BELLEVILLE COMBINED LICENSE APPLICATION – RESPONSE TO REQUEST FOR  
ADDITIONAL INFORMATION – VIBRATORY GROUND MOTION

Reference: Letter from Joseph Sebrosky (NRC) to Andrea L. Sterdis (TVA), Request for  
Additional Information Letter No. 125 Related to SRP Section 2.5.2 for the  
Belleville Units 3 and 4 Combined License Application, dated  
September 19, 2008

Response to NRC Request for Additional Information letter No. 125 dated September 19, 2008  
(20 pages, including this list)

Subject: Vibratory Ground Motion in the Final Safety Analysis Report

**FIGURE 1**  
 Elevation of the Base of Layer C in Map View (from FSAR Figure 2.5-297)

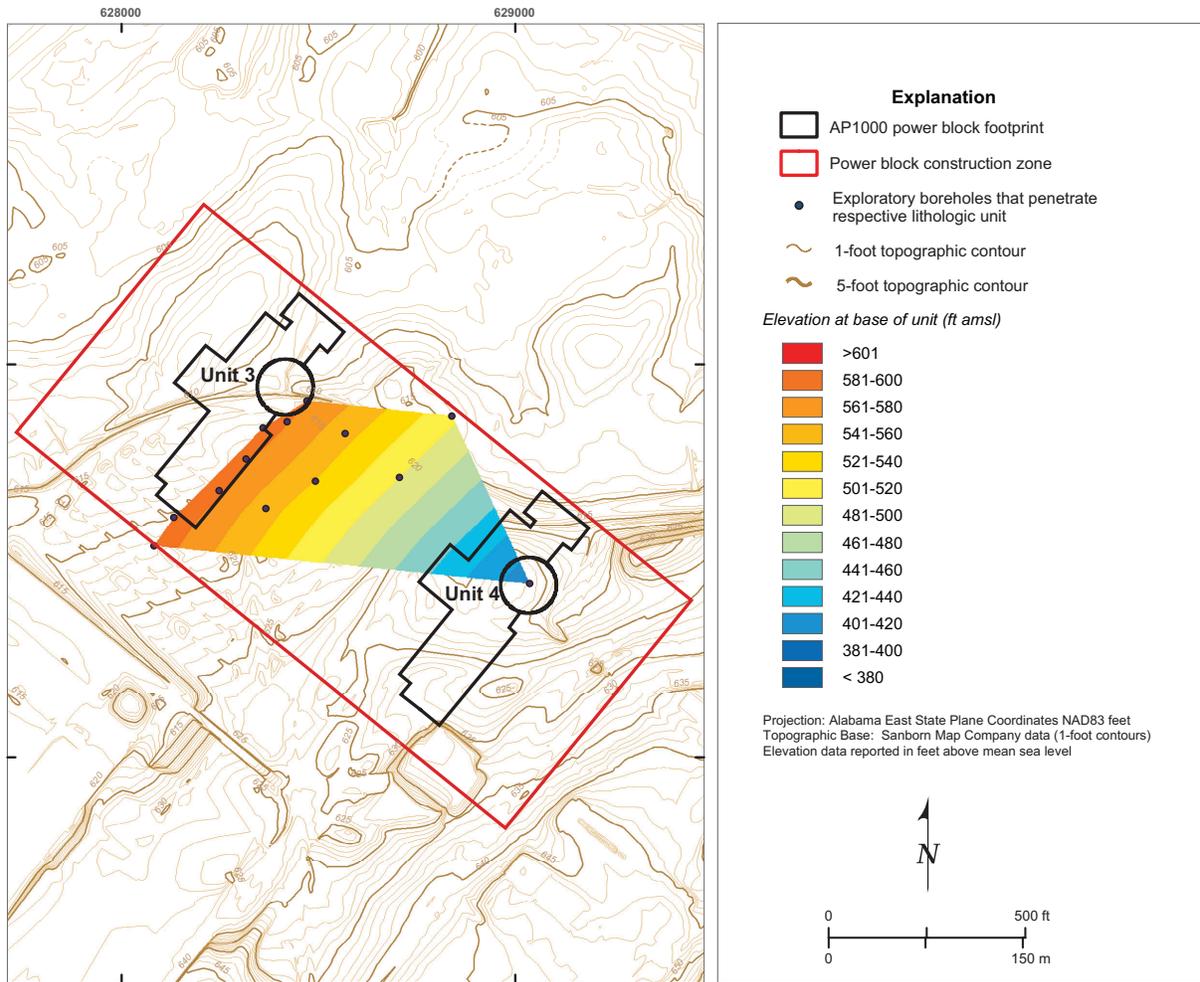
FSAR Section 2.5.2.5 describes the site as a hard rock site and states that two thirds of the measured rock section exhibits shear wave velocity of 9,200 fps or greater. Please explain whether the existence of the layer C disqualifies the site as a “hard rock” site because the layer has a shear wave velocity of about 6000 fps (FSAR Figure 2.5.-299) and provide the basis for your decision not to do a site response analysis to evaluate the effect of the underlying lower shear wave velocity layer. In addition, please explain the potential impact of this material on the GMRS calculation.

Figure 1 (Attachment 02.05.02-02A) shows that layer C comprises about 20% of the surface footprint of Bellefonte Reactor Unit 3. After accounting for interface depth and dip uncertainties, the maximum thickness of layer C beneath Reactor Unit 3 of about 16 ft occurs in the southeast corner of the Reactor Unit 3 footprint. The portion of layer C beneath the Reactor Unit 3 footprint corresponds to the bottom <16 ft of layer C in the stratigraphic section as shown on Figure 2 (Attachment 02.05.02-02B). Figure 2 also shows that three velocity logs intersect this lowest 16 ft section of layer 3. As shown on Figure 3 (Attachment 02.05.02-02C), these velocity logs demonstrate that a conservative estimate of the average shear-wave velocity of layer C beneath Reactor Unit 3 is 7000 ft/s. The closest portion of layer C to the Reactor Unit 4 footprint is 110 ft below plant grade (Figure 2).

**FIGURE 1**  
Location Uncertainty of Seismicity

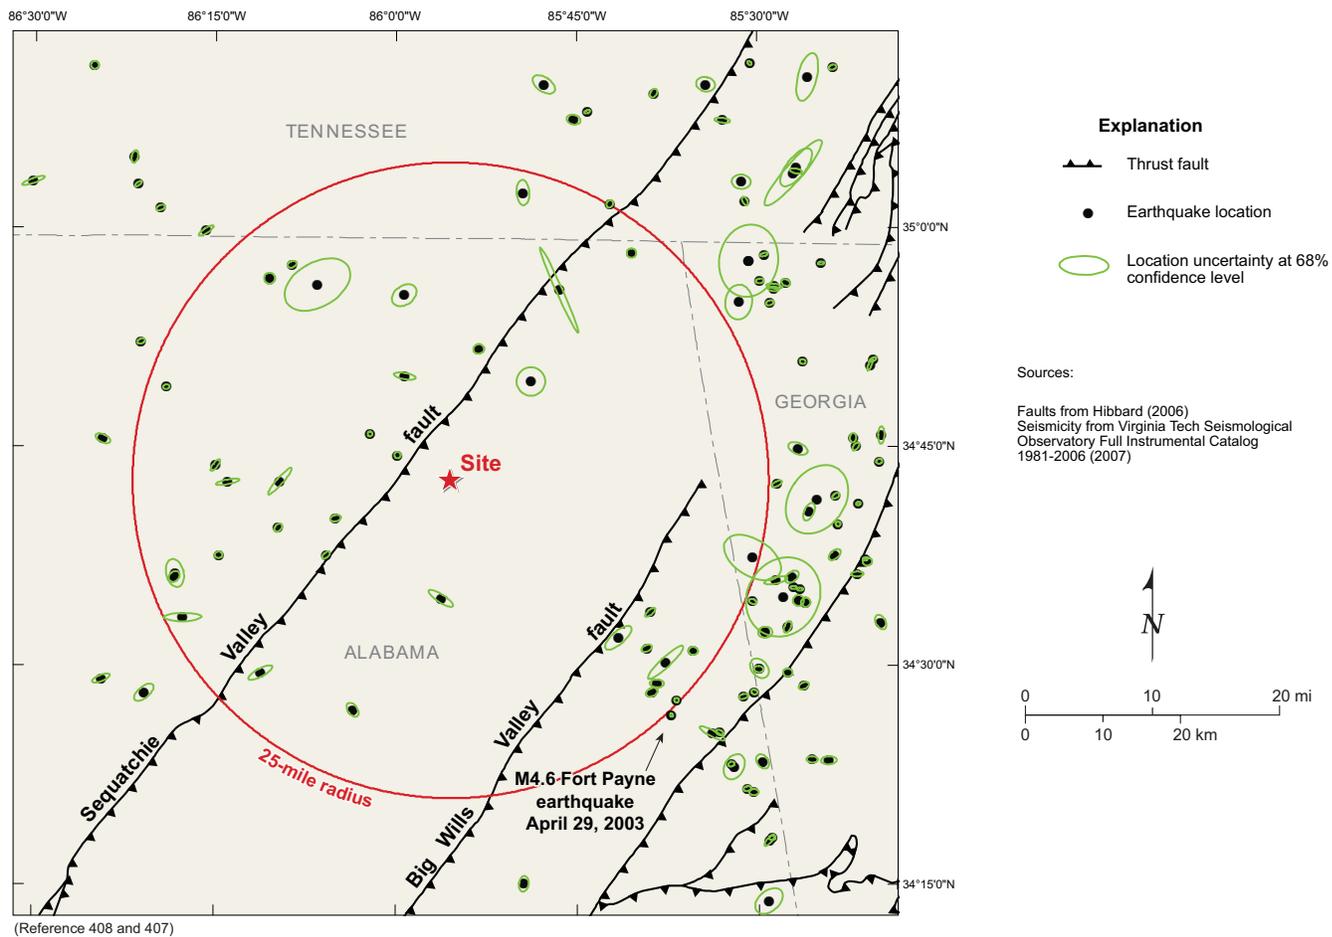
FSAR Subsection 2.5.2.1.2, "Recent Earthquake and Historical Seismicity" describes basic parameters associated with the April 29, 2003, Fort Payne earthquake. Please explain the uncertainty in determining the focal depth of the earthquake in terms of the distance of the nearest seismography station, seismic network distribution, availability of aftershock network, velocity structures and direct evidence from seismograms. In addition, please provide an explanation on depth uncertainties for the events plotted in the FSAR Figure 2.5-294. Given the level of the uncertainty in determining the depth of an earthquake in the area, please explain how you determined these events related not to ruptures above the detachment (for example, on the Sequatchie fault) but rather to the mid crust structures beneath the detachment.

Figure 1 (Attachment 02.05.02-03A) shows the projections of the 68% hypocenter error ellipsoids in the horizontal plane for instrumentally located earthquakes in the site vicinity as reported in Table 1. Most earthquakes within 25 km of the site are located to the northwest of the surface trace of Sequatchie Valley thrust, of Late Paleozoic age, which dips to the southeast. Figure 1 shows that the epicenter semi-major

error ellipse axes (68% confidence) are on the order of 2 km or less for most of these events, suggesting that they are determined with sufficient accuracy to support the interpretation that the majority occurred to the northwest of the Sequatchie Valley fault and therefore, have no relation to that feature.
